City of
Richmond

Report to Development Permit Panel

File: DP 18-820689

**Re: Application by Integrated Construction for a Development Permit at
1600 Savage Road
(Re: Referral from April 27, 2020 Council Meeting)**

X Trees removed without a permit

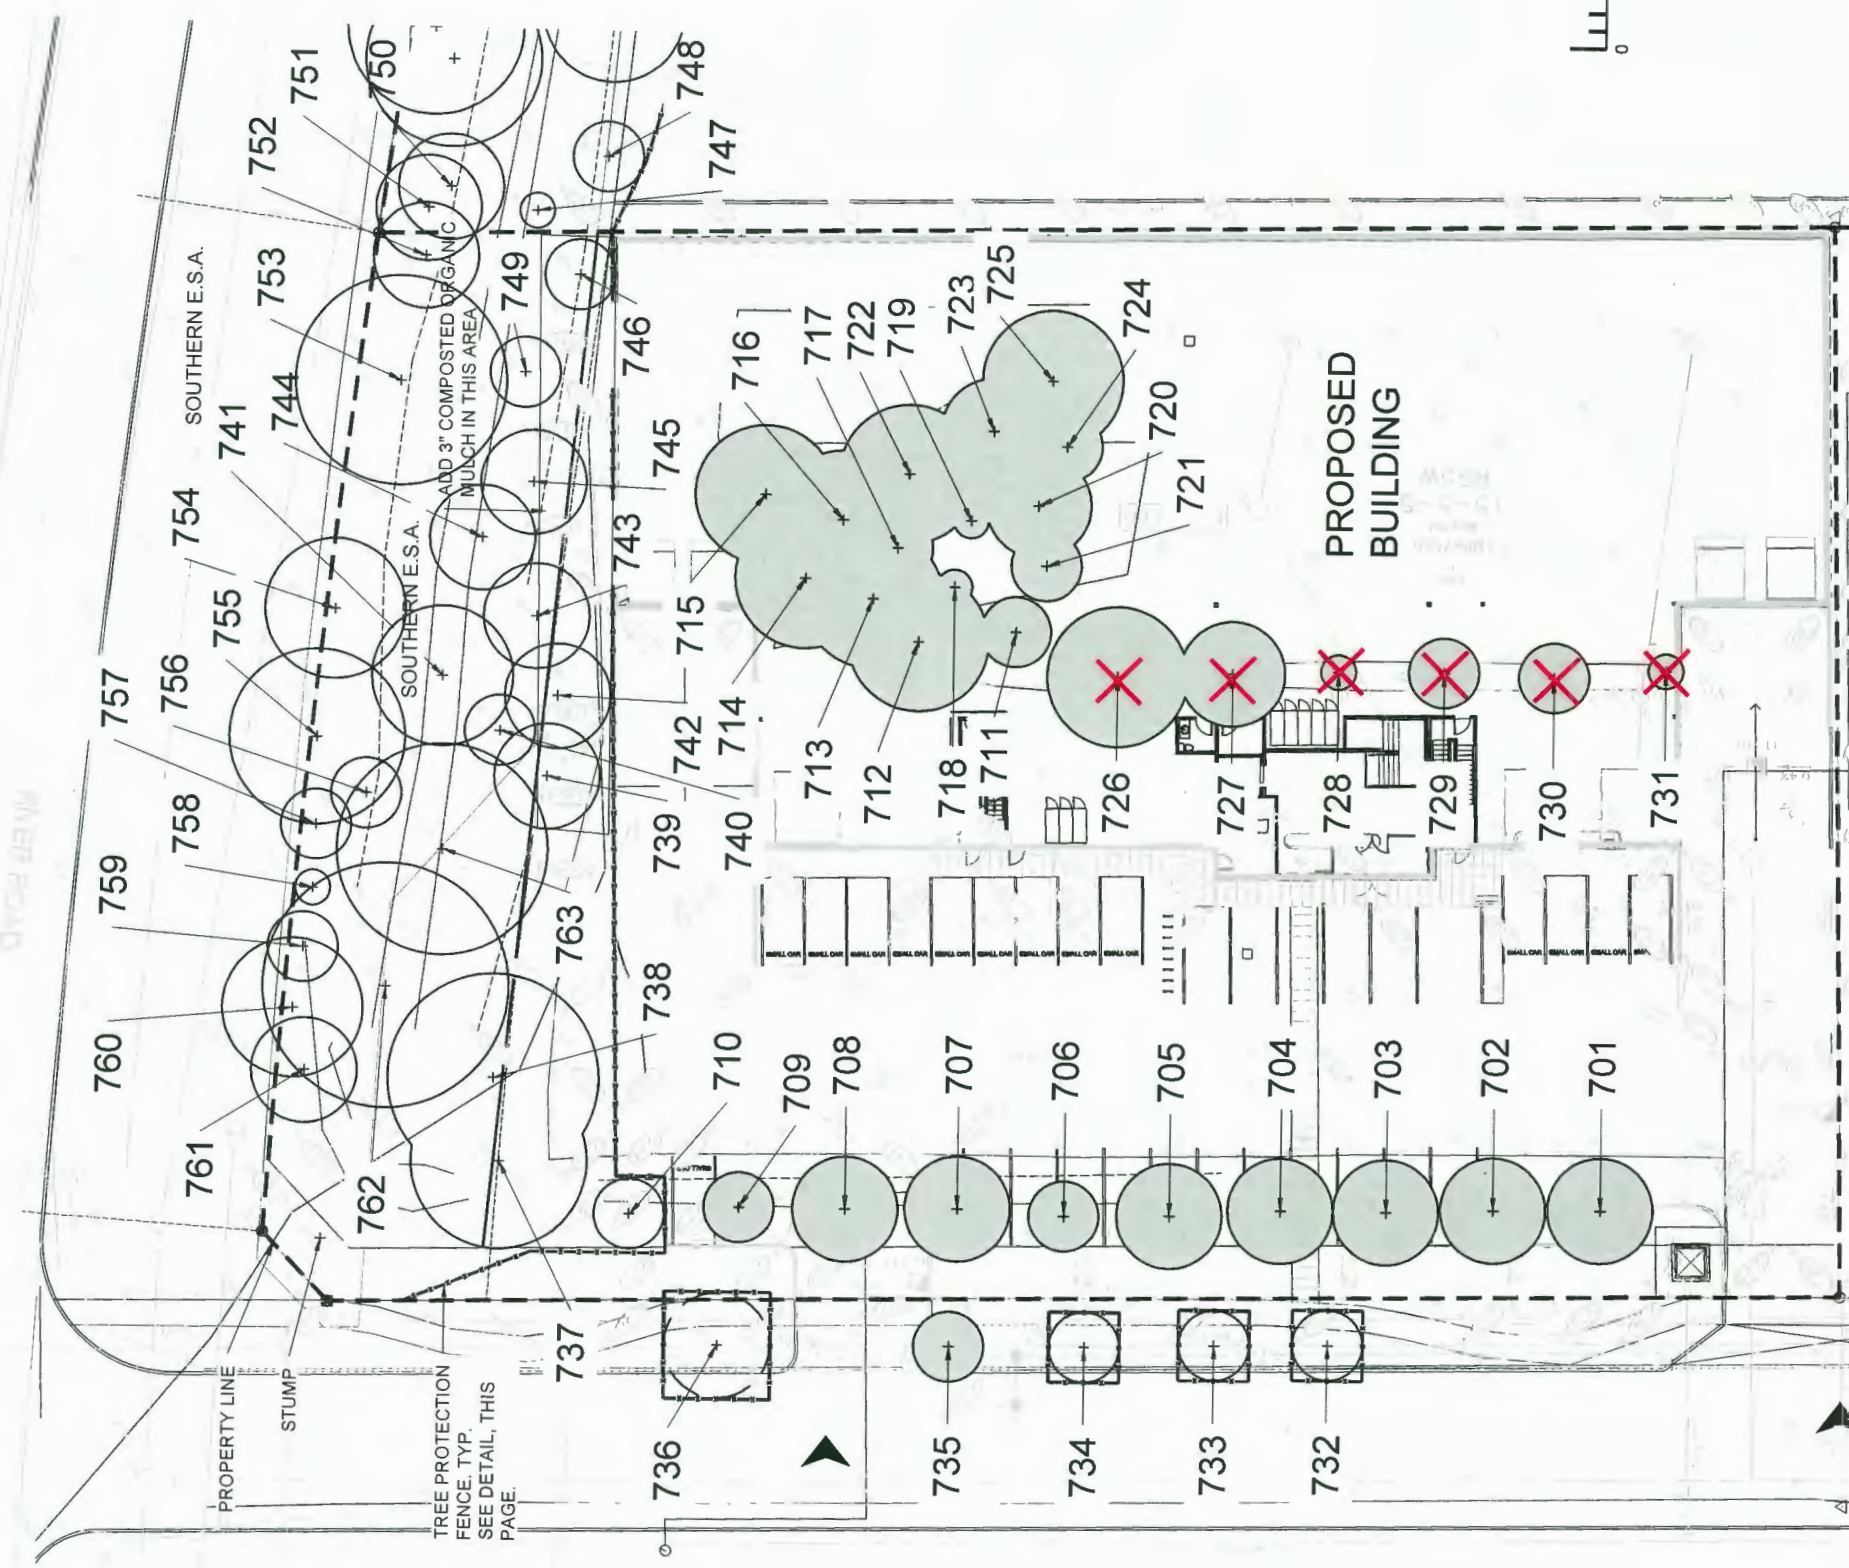
- ***As a result of staff inspections, the City's Tree Preservation Officer also identified that six trees (tag# 726, 727, 728, 729, 730 & 731) were removed prior to Development Permit issuance and without Permits (Attachment B). The property owner and applicant were each fined \$6,000 for the removal of the trees, for a total of \$12,000 in fines, which have been paid. Staff note that the trees which were removed without a Permit were located outside of the ESA and had been identified for removal through the Development Permit application process.***
